UNITED STATES PATENT AND TRADEMARK OFFICE

Office Action Summary

10/727,673

DETAILED ACTION

As for Claim 1, Thompson discloses of a ring (see figure below) comprising:

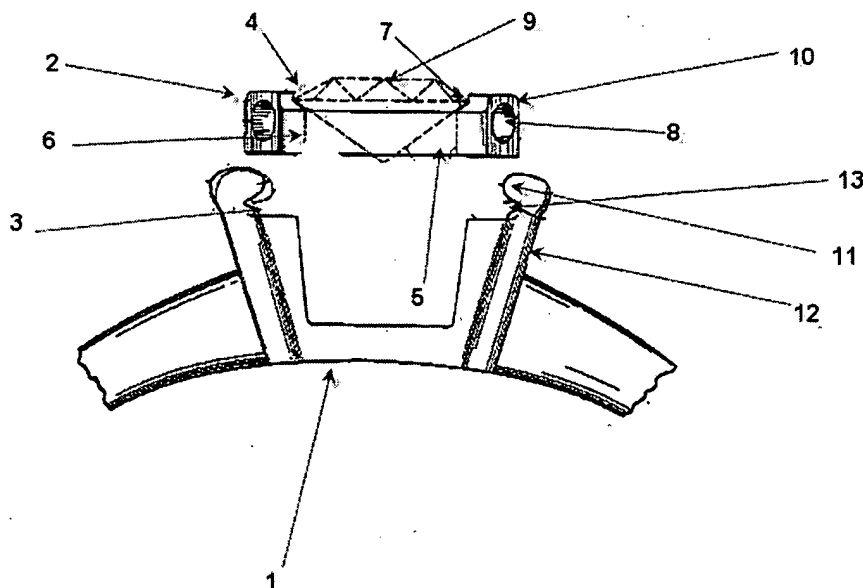
(a) a band (1);

(b) a hollow bezel (2) secured to a first portion (3) of said band (1) and having an open top (4), and open bottom (5), an inside wall (6) defining a lumen extending between said open top (4) and said open bottom (5), a seat (7) within said lumen (6), and an outside wall (10) having an exterior recessed section (8);

(c) a stone (9) mounted at least partially within said lumen (6) of said bezel (2) and in contact with said seat (7); and

(d) a hook (11) at a second portion (12) of said band (7) and having an opening (13) sized to receive the recessed section (8) of said bezel (2) to clasp the two portions (3, 12) of the band (1) together, wherein when said hook (11) has received the recessed section (8) of said bezel (2), the hook (11) is impeded from detaching from the bezel (2) by either the top or bottom of said

bezel (2) (it would take force to detach the bezel, so therefore it is considered “impeded” from detaching from said bezel).

Re: Claim 3, wherein said band (1) has spring characteristics (part 3, line 64, stating, “In the initial position...toward the center of the head just far enough to be sprung slightly outwardly as...”)) such that the band (1), hook (11) and bezel (2) all cooperate to hold the inside of the hook (11) against the exterior recessed section (8) of the bezel (2) as the piece of jewelry is worn.

Re: Claim 5, wherein the outside wall (10, including that of 8) of said bezel (2) has a substantially hour-glass shape (due to the “concave exposed area in which is formed a socket” represented by 8; the concavity of the socket gives the outside wall a hour-glass shape).

Now as for Claim 7, Thompson teaches of a ring (see figure above) comprising:

(a) a band (1) having first (3) and second portions (12);

(b) a bezel (2) secured to said first end (3) of said band (1), said bezel (2) having an outside wall (10) comprising a top section, a bottom section and a recessed center section (5), an open top (4), an open bottom (5), and an inside wall (6) defining a lumen extending between said open top(4) and said open bottom (5), and a lumen wall (6) having a seat (7), and at least one recess (7).

(c) a hook (11) formed at said second end (12) of the band (1);

(d) a stone (9) positioned at least partially within said lumen (6) of said bezel (2) and in contact with said seat (7); and

(e) a seat bead (Thompson in view of (e) from Fig. 3 or 4 of Guild) positioned within said recess (7) cooperating with said seat (7) to hold said stone (9) to said bezel (2),

wherein said hook (11) receives said recessed center section (8) of said bezel (2) to secure said first (3) and second portions (12) of said band together (via bezel, 2).
